Birrong Station Upgrade

Determination Report

Birrong Station Upgrade – Determination Report

Figure 3 Revised key features of the Proposed Activity (indicative only, subject to detailed design)

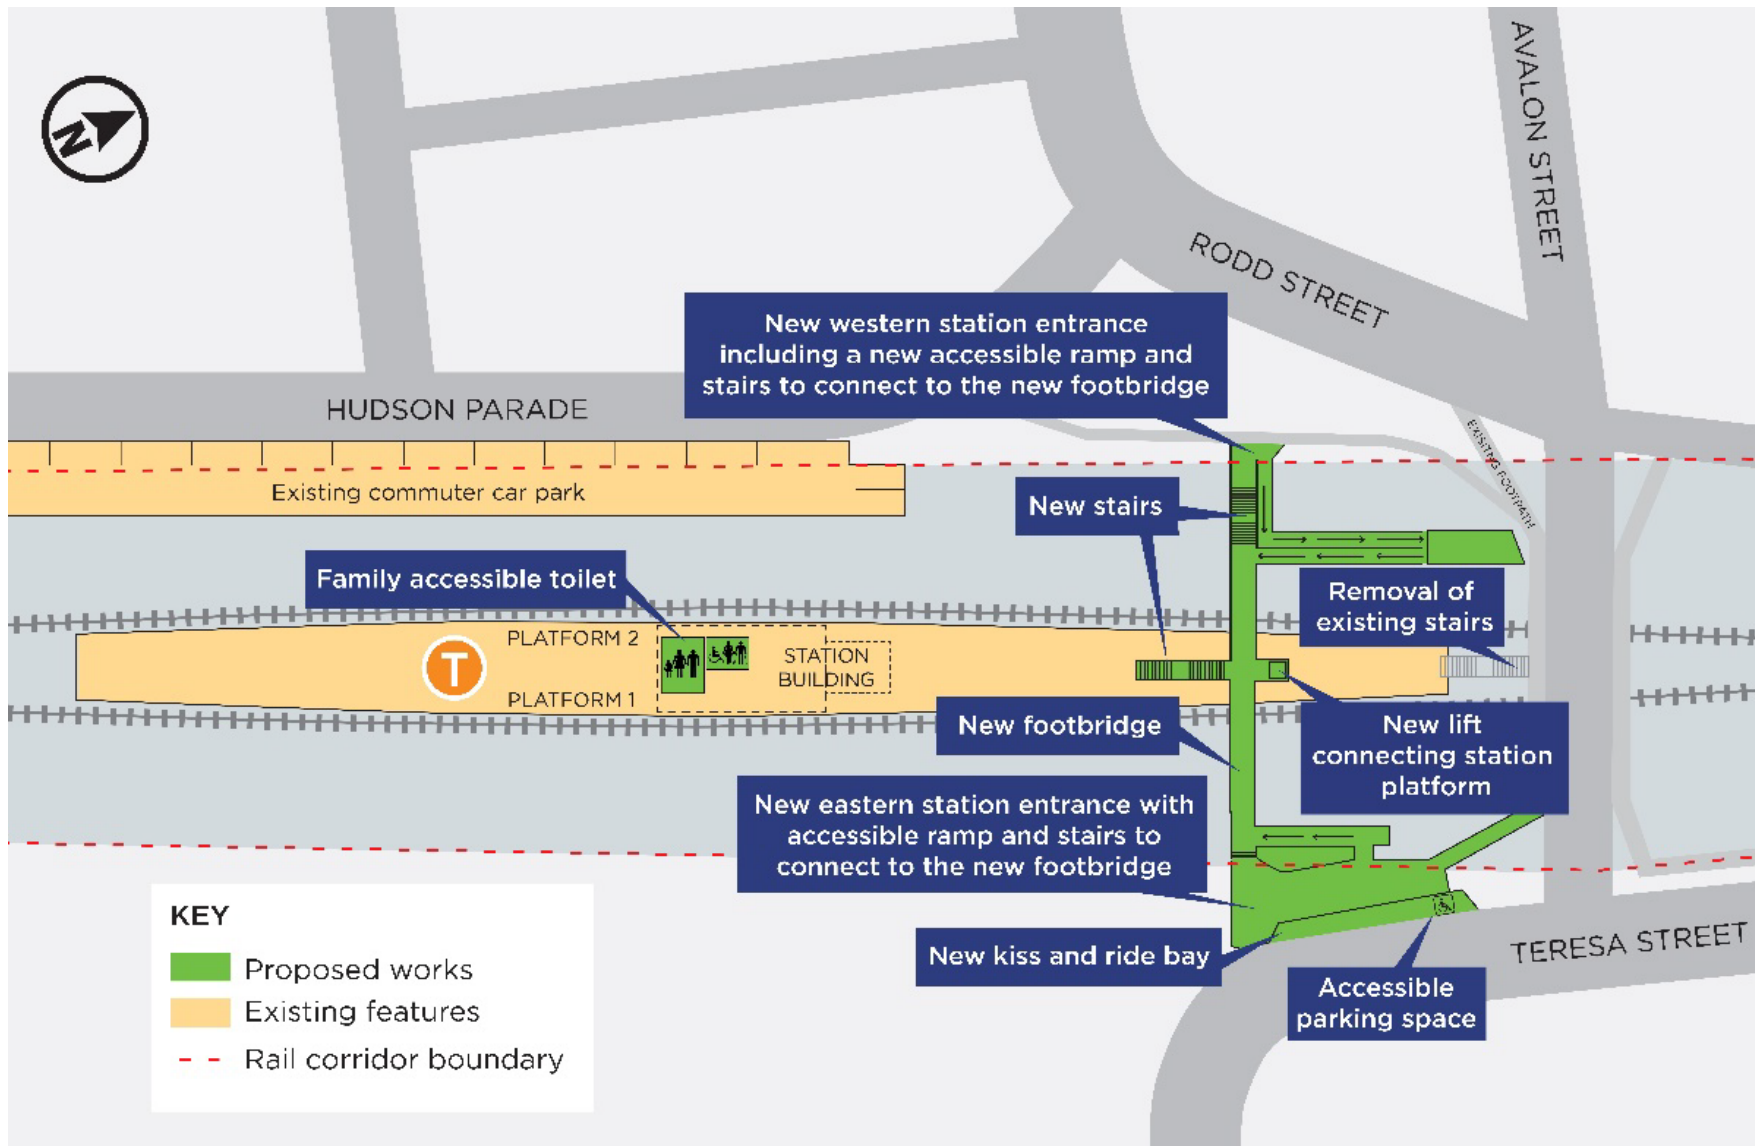
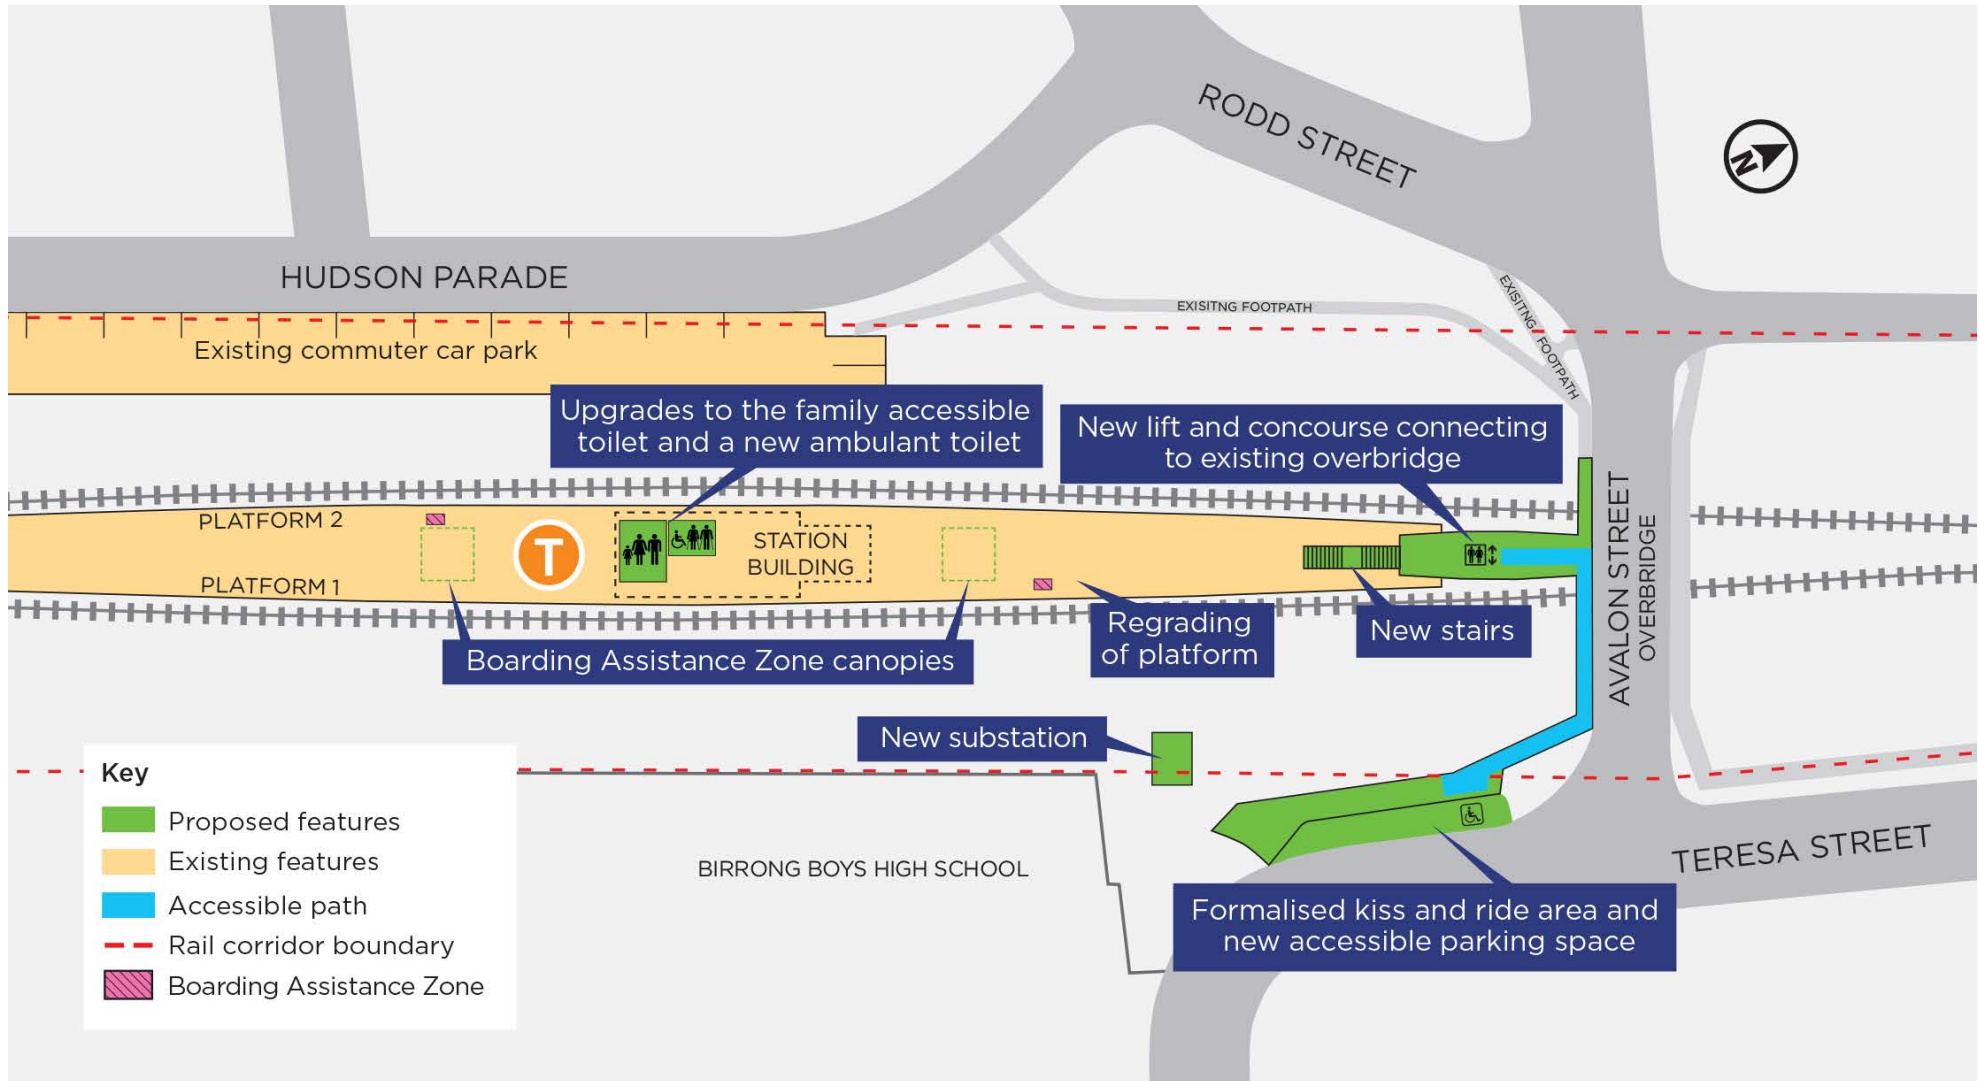
A change to the design of the Proposed Activity has been made since the public display of the Birrong Station Upgrade REF. The key changes to the design are:

Aspect of the Proposed Activity	Original Design	Revised Design	Discussion of impacts
Footbridge, lift and stairs	<ul style="list-style-type: none"> removal of the existing stairs to the platform from the Avalon Street overbridge and reinstating the existing bridge parapet installation of a new pedestrian footbridge south of the existing Avalon Street overbridge which would provide access from Rodd Street (east) over the rail corridor to Rodd Street (west). The footbridge would comprise of a concrete structure with protection screens installation of one lift to provide access between the new pedestrian footbridge and the platform construction of a new eastern station entrance, to include accessible ramp and stairs to connect to the new footbridge, with landscaping near the entrance construction of a new western entrance, to include a new accessible ramp and stairs to connect to the new 	<p>Since public display of the REF, design development further explored the opportunity to utilise existing infrastructure to minimise construction impacts and maintenance requirements whilst still achieving TAP program objectives.</p> <p>Subsequently, Option 1 detailed in the REF has been developed to overcome the initial challenges relating to customer access to the station during construction and heavy vehicle access during operation. A temporary footbridge structure would be installed for customers to access the Station duration of construction. Works on the Avalon Street overbridge would include the removal of the existing concrete median island and new line marking is proposed to accommodate footpath widening. These aspects are discussed in the 'Site compound and temporary works' and 'Interchange upgrades' sections of this Table respectively.</p>	<p>The key difference between the original design and the revised design is the replacement of a proposed separate footbridge extending over the rail corridor (including a central lift and stair), with a new lift/concourse/stair arrangement from the existing overbridge on Avalon Street.</p> <p>Further assessment of the revised design has been undertaken to consider the changes to visual and amenity impacts on surrounding receivers, which is detailed below.</p> <p>It is considered that there would be negligible changes to other key environmental impacts such as construction and operational traffic, construction noise and biodiversity. Therefore, the remainder of environmental impact assessments undertaken as part of the REF (December, 2019) remain applicable to the revised design.</p> <p>The following section provides a summary of the addendum landscape character and visual impact assessment that was undertaken for the revised design of the Proposed Activity.</p> <p>Addendum Visual Impact Assessment</p> <p>An addendum Landscape Character and Visual Impact Assessment (LCVIA) report (Envisage, 2020) was undertaken for the revised design of the Proposed Activity (refer to Appendix C).</p> <p>The LCVIA concluded that the revised design of the Proposed Activity would have a reduced overall impact to landscape character and surrounding viewpoints during construction, compared to the original design. Once constructed, the revised design of the Proposed Activity would have a slightly lower visual impact due to its direct association with the Avalon Street overbridge, smaller overall structure and decreased visibility from outside the railway corridor.</p>
